ADDENDUM 1

March 27, 2026

**Skyline Elementary School
HVAC Replacement
DSA APPL. # 01-122566**

South San Francisco Unified School District
398 B Street
South San Francisco, CA 94080

A2.03

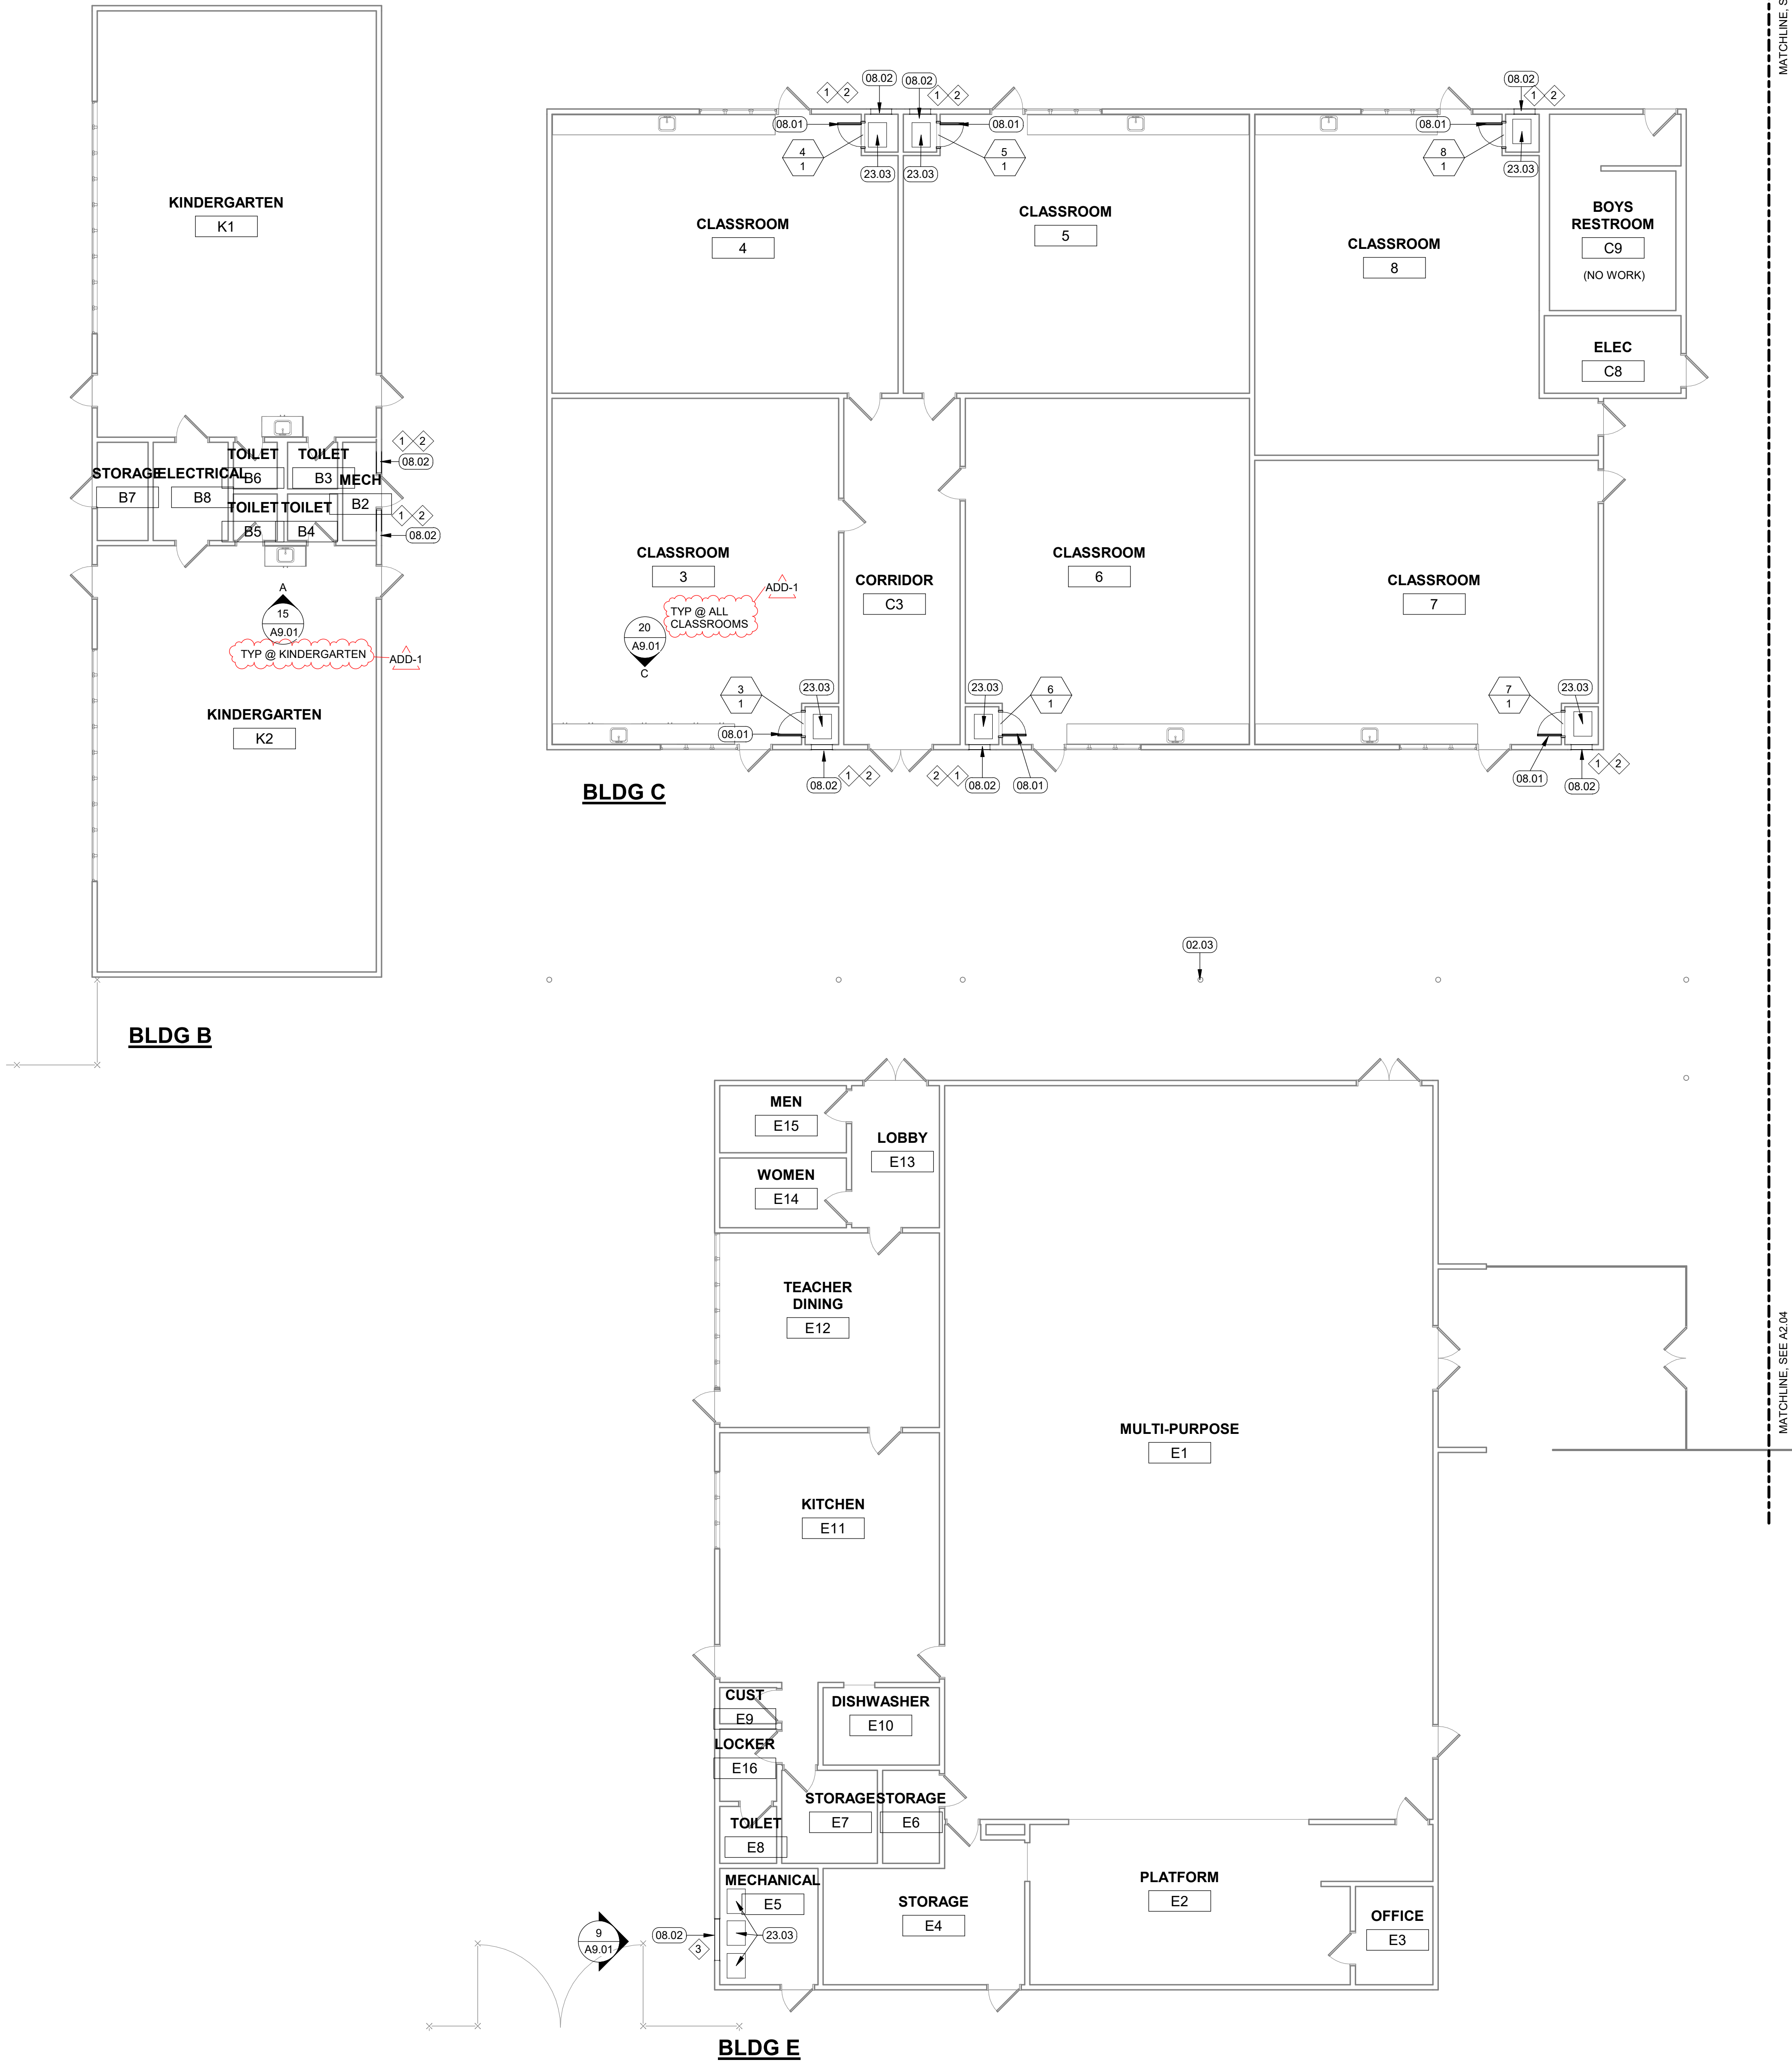
- A2.03 Note "TYP @ KINDERGARTEN" and note "TYP @ ALL CLASSROOMS" **added** to interior elevation tag.
- A2.04 Note "TYP @ ALL CLASSROOMS" **added** to interior elevation tag.
- A2.04 Interior elevation callout **revised** from 2 to 3/A9.01.
- A9.01 Detail 20 **revised** to provide direction for wallcovering finish.
